U. S. NUCLEAR REGULATORY COMMISSION
REGION IV

NRC Inspection Report: 50-445/84-05

Facility Name: Comanche Peak Steam Electric Station (CPSES), Unit 1

Areas Inspected: Special, unannounced inspection of allegations of poor work practices pertaining to safety-related supports. The allegations covered five separate items identified by the alleged to NRC personnel. All identified items pertained to the main steam pipe supports. This inspection involved 290 inspector-hours onsite by two NRC inspectors.

Figure 1

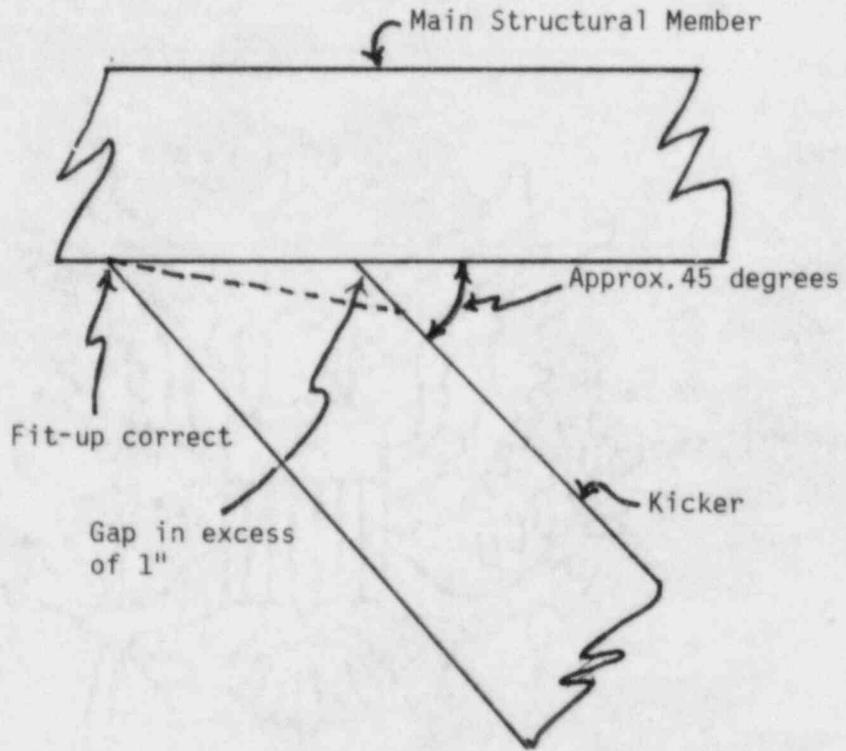
The initial signed statement made by the alleged did not identify a specific problem with MS-1-004-007-C72K. However, during the site visit on January 6, 1984, the support was identified by the alleged as having an excessive gap (1" or more) between the main structural member and the kicker at fit-up. The kicker meets the main member at approximately a 45 degree angle. The excessive gap was welded closed.

After inspection of the kicker attachment weld (described below), the alleged was informed of the results. The alleged then indicated that the fit-up was correct on one side of the attachment only, and that the weld prep tapered out to an excessive gap of greater than one inch on the opposite side. See Figure 1.

The NRC inspectors could not identify any evidence that would support the allegation regarding an excessive gap and unauthorized welding. There is evidence to support that the weld fit-up was done correctly. Observation of the etched areas and inspection of the remainder of the suspect weld confirmed that the requirements of the drawings were met. The requirement for weld preparation for the plates in question show that a 45 degree prep on a 1" plate for the full penetration weld with 1/8" clearance will give a 1" gap at the top of the area to be welded. See Figure 3. This is normal and according to procedures.

The allegation could not be confirmed based on the inspection record, discussion with other personnel working in the area, and direct observation of weld area which included grinding and etching of two areas on the weld.

Figure (2)

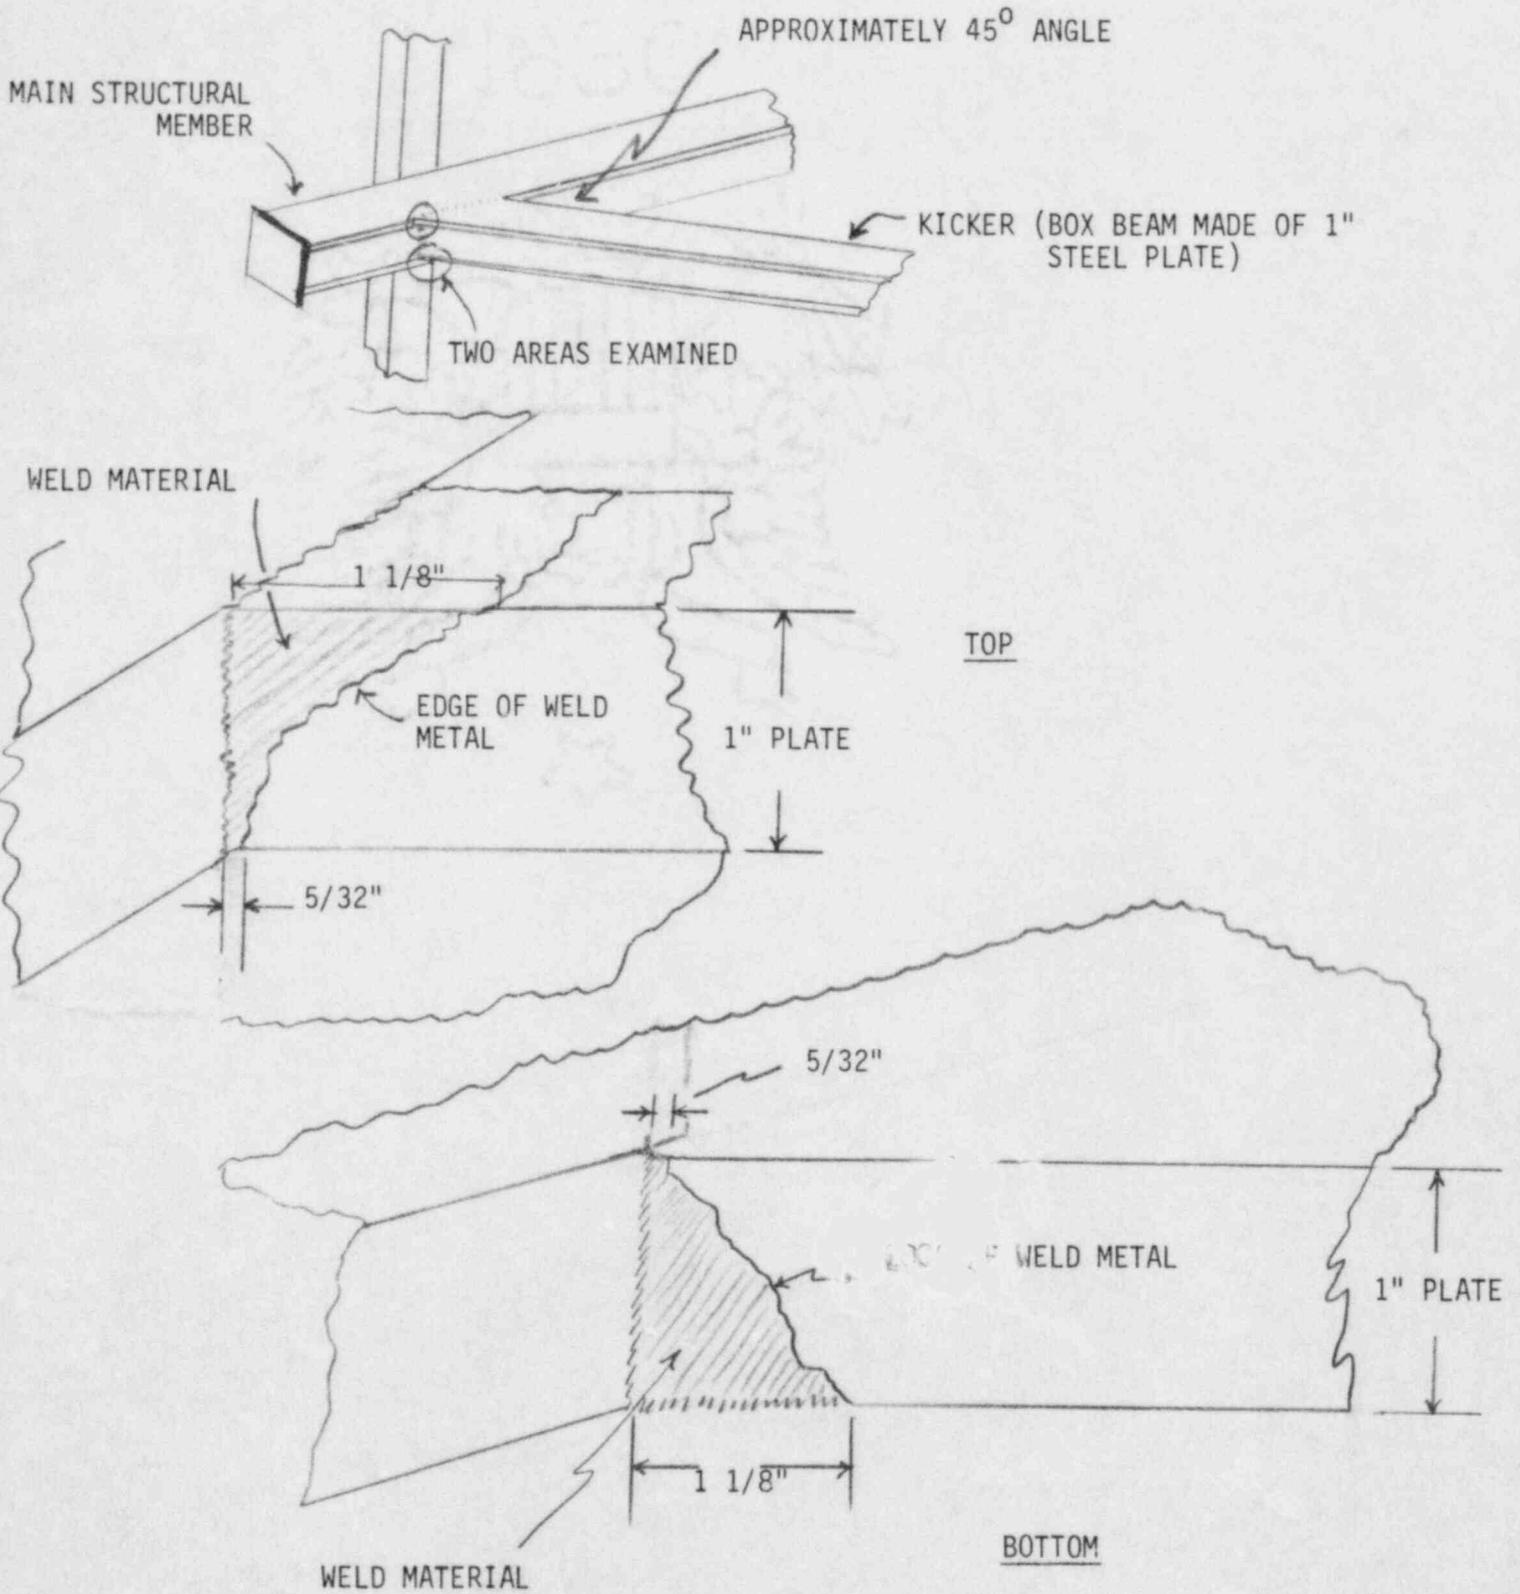
At the request of the NRC inspectors, the licensee had B&R grind and etch two areas on the support. Figure 2 shows the areas examined and the observation noted. In addition to the two etched areas examined, the NRC inspectors found that the weld joining the lower kicker to the main support member was consistent in appearance (approximately 1" wide) for the full length of both the upper and lower welds. On the inside angle of the kicker (45 degrees), a small edge of the weld prep (See Figure 3) was noted approximately 1-1/8" from the edge of

plate A. The bottom weld was similar in appearance. The support had been painted; however, the size of the weld was noted to be consistent with the requirements of the B&R drawings and consistent with the experience of the NRC inspectors for similar type welds. Additional destructive testing was not done based on the evidence noted.

Figure 4

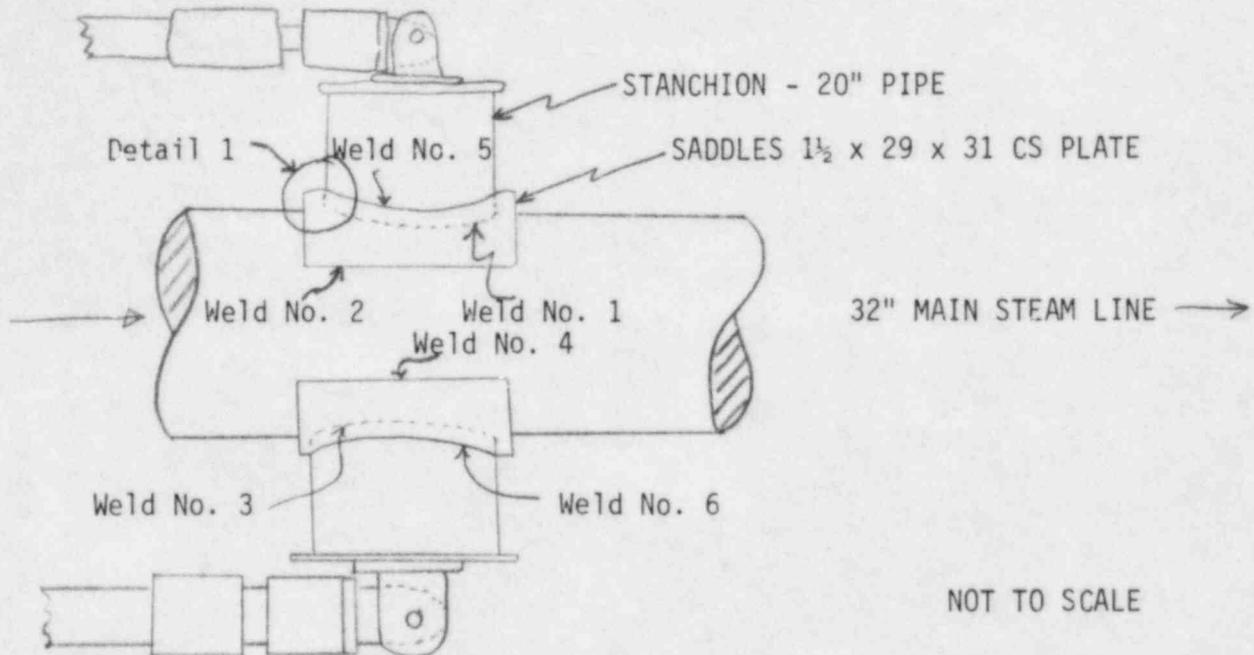
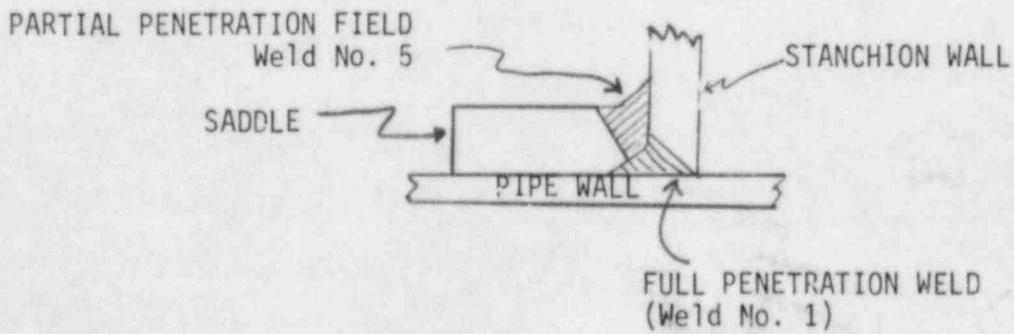
This support is a large ASME Code Class 2 pipe support located on the 893' 10" elevation of Unit 1, Containment Building. It extends approximately 4' out from the wall. The two support members parallel the 32" main steam line, one on top and one below. There is an upper and lower stanchion welded to the pipe, made of 20" schedule 60 pipe. The stanchions are, in turn, reinforced by 1-1/2" x 29" x 31" CS "saddle" plates also welded to the pipe. Two SMF-100-BA snubbers connect the main structure to the stanchions. See Figure 4.

The allegor identified MS-1-003-010-C72K during the January 6, 1984, site tour. The specific problem identified was that the lower saddle had been heated to a "cherry red" condition and bent into shape around the main steam line using a come-a-long and a porta-power hydraulic jack.

During the January 26, 1984, discussion, th allegor stated that the lower saddle (on MS-1-003-010-C72K) had been cut into four pieces, and that the left hand, back quadrant piece had been heated and bent into position with a porta-power unit, a 1 ton chain "come-a-long," and hammering. The heating and bending operation was not an approved method or procedure. In addition, the allegor stated that he, in company with a welder, went to B&R management with this allegation. To the best of the allegor's knowledge, nothing was done by B&R to resolve the problem.

- MS-1-003-010-C72K stanchions were welded in place from July 13, 1981, to July 23, 1981 (WDC 45201)
- The upper saddle was cut in two pieces and repaired in accordance with CMC 53580. The item was cut incorrectly in fab shop.
- The lower saddle is one piece, with no visual indications that the saddle was split. It is smooth, without marks indicating that a chain or hydraulic jack was used to bend the saddle.
- The saddles were welded in place between August 11, 1981, to August 19, 1981 (WDC 45197).
- QC inspections of fit-up and welding indicate welds are "satisfactory."

Based on the information obtained from B&R personnel, review of the support packages and direct observation of the supports, the allegation could not be substantiated. The original support identified did not have a saddle cut in four pieces. The support that did have a four piece saddle also had clear and direct authorization to make such a change.
